YUCCA MOUNTAIN PROJECT

CHANGE CONTROL BOARD RECORDS

VOLUME VIII FY 1989

IDS Data Acquisition Station

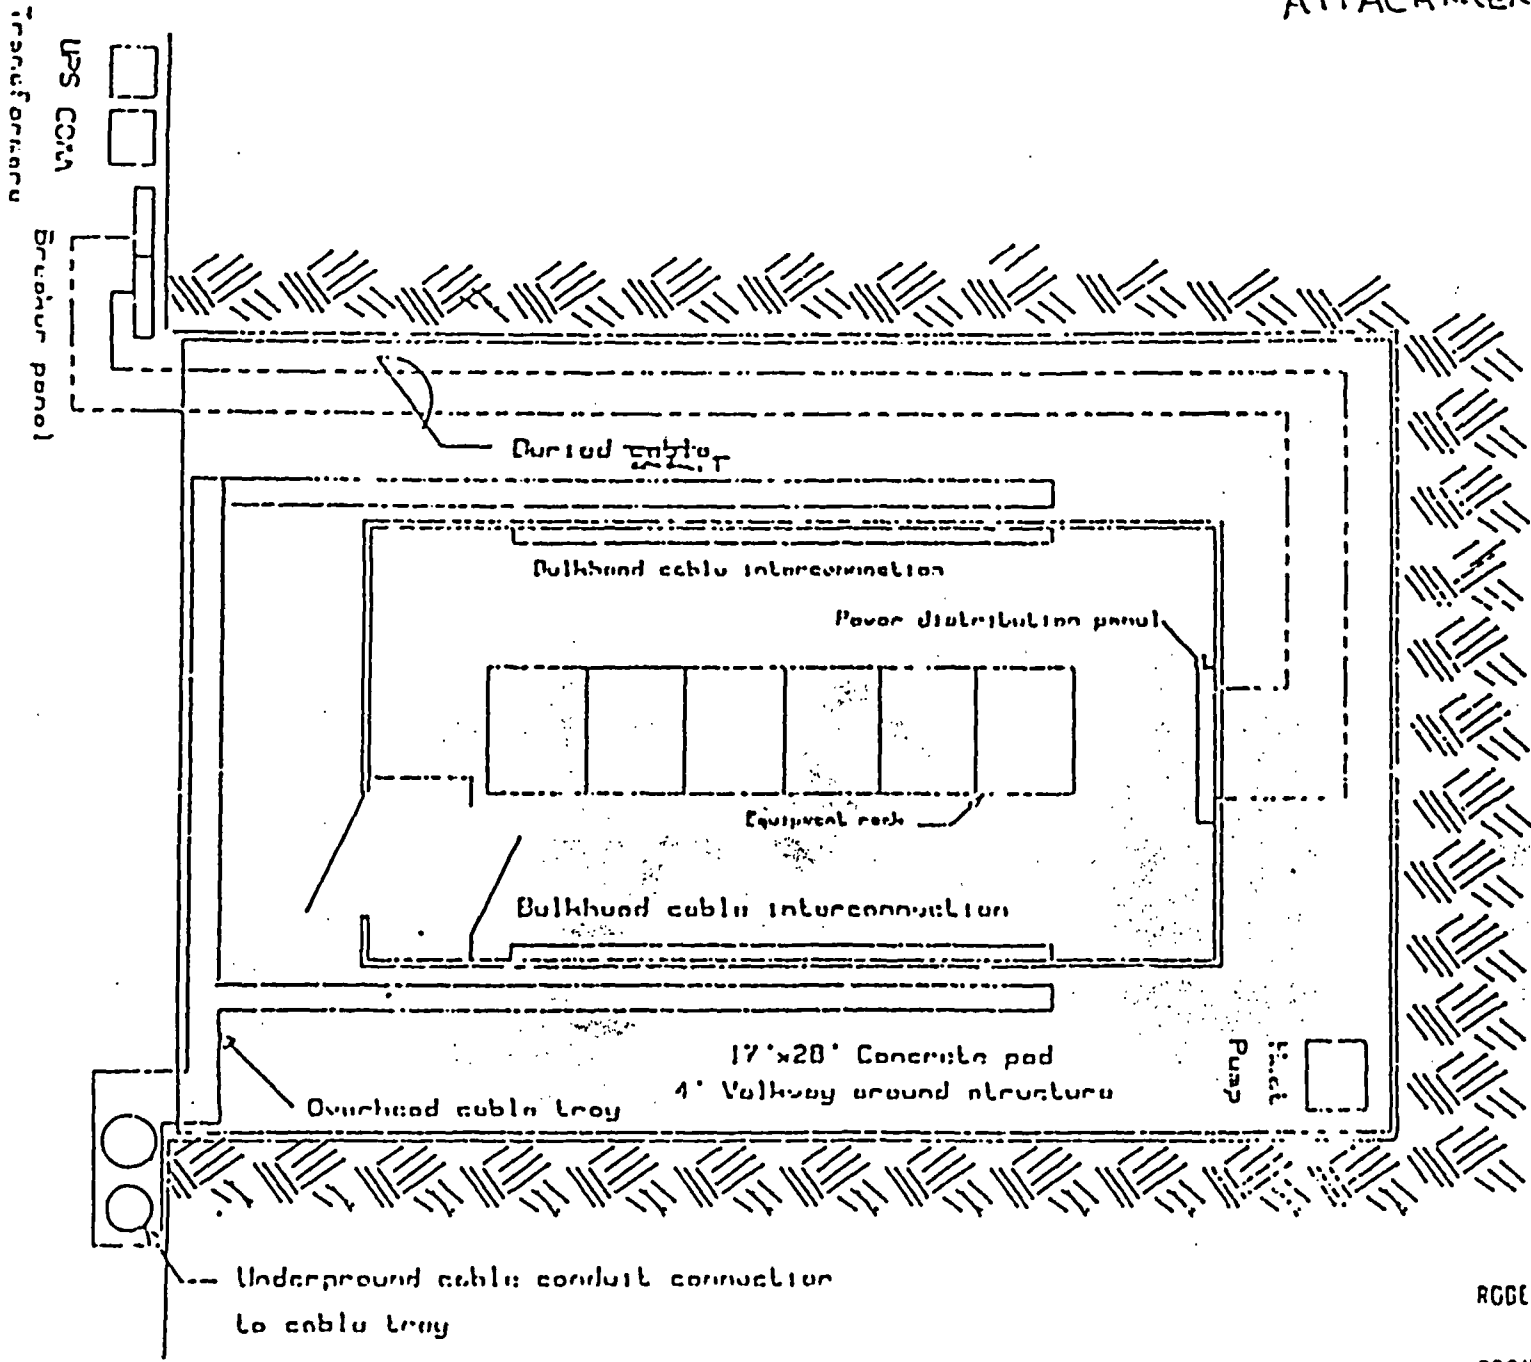
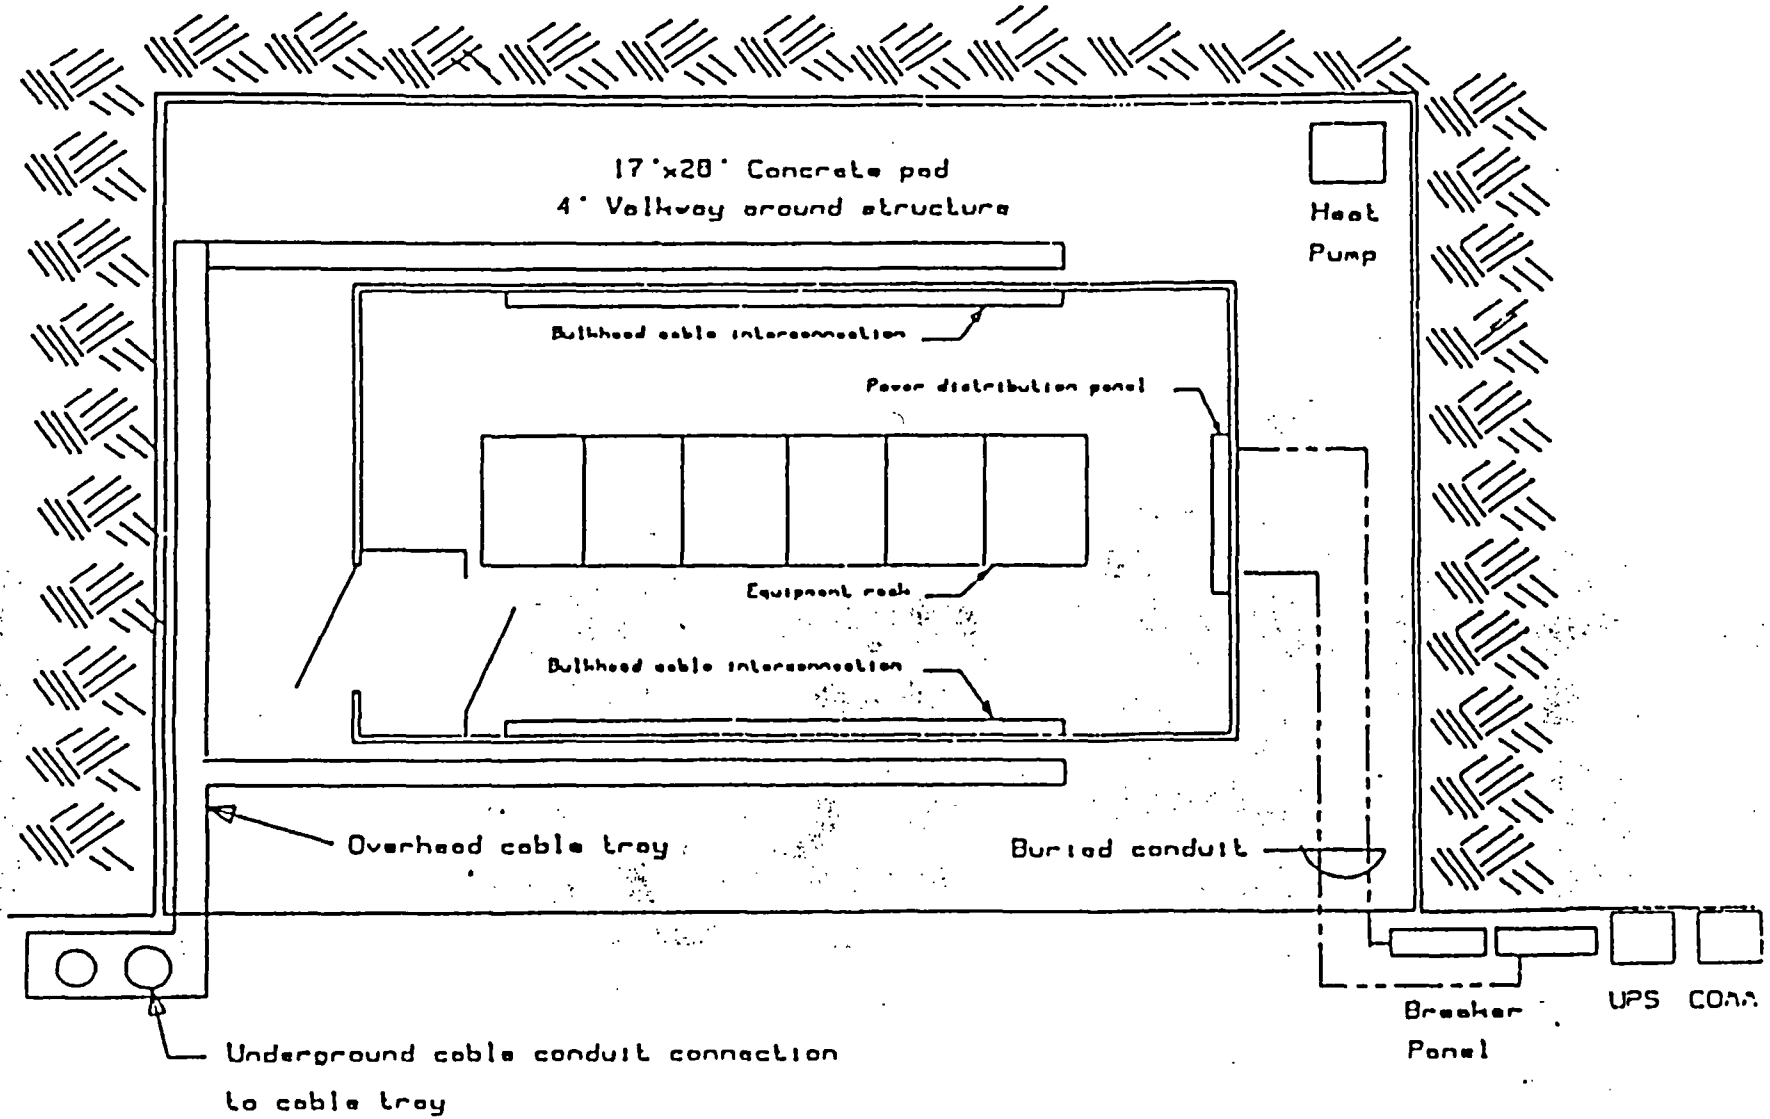
The sketch for the IDS Data Alcove and the IDS Data Acquisition Stations at the main test level will be revised and coordinated through the ICWG.

Figure 2

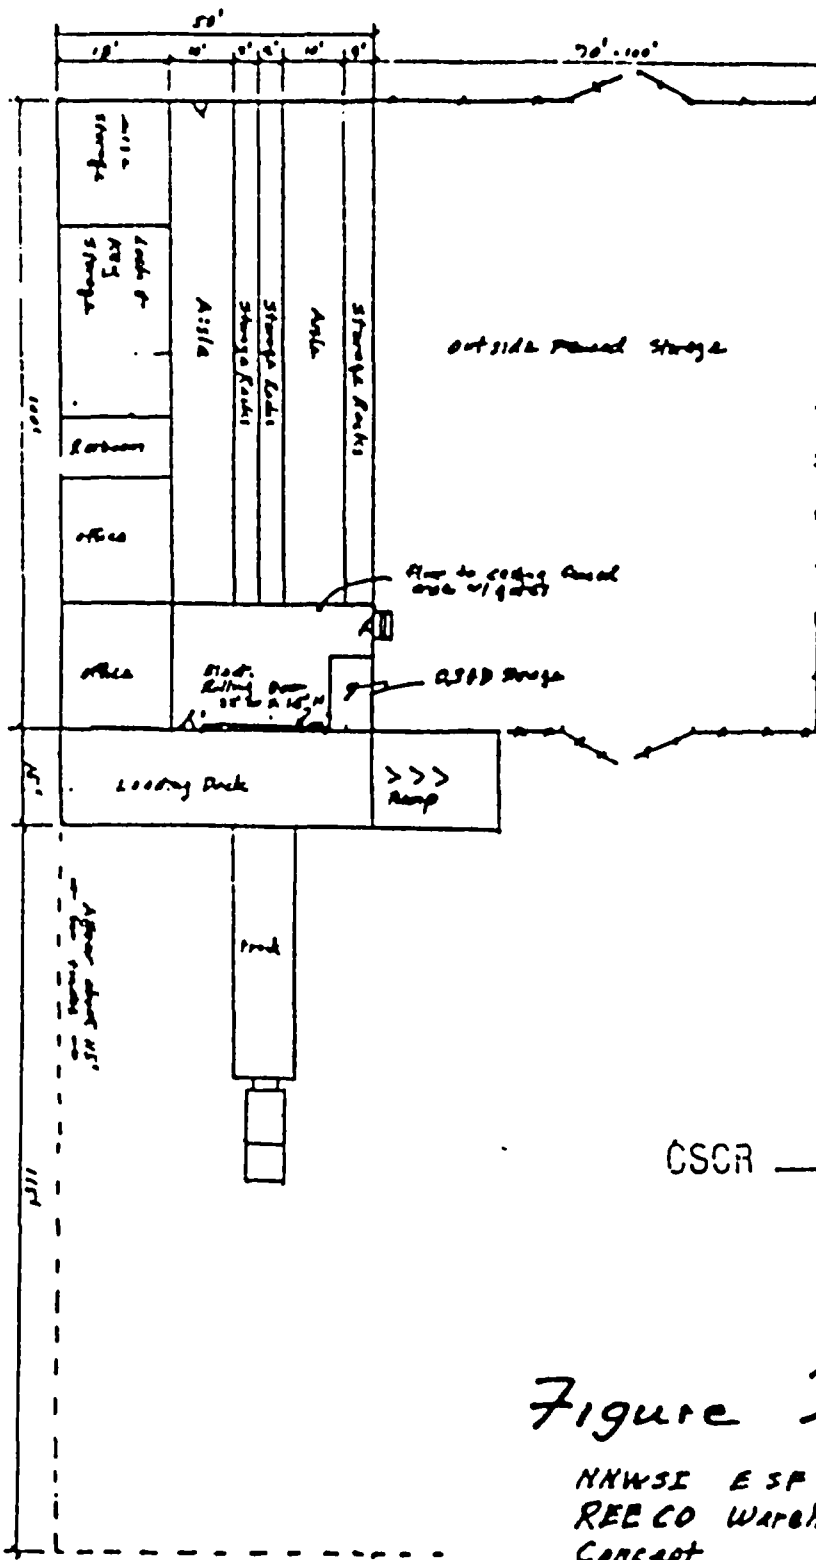
The numbers of line items which will be stored are estimated to be between 2,000 and 3,000 items. In addition, the warehouse staff will control all of the items stored in the controlled yard(s). Figure 2, Conceptual Warehouse, which contains all of the above listed features is presented with this ECR.
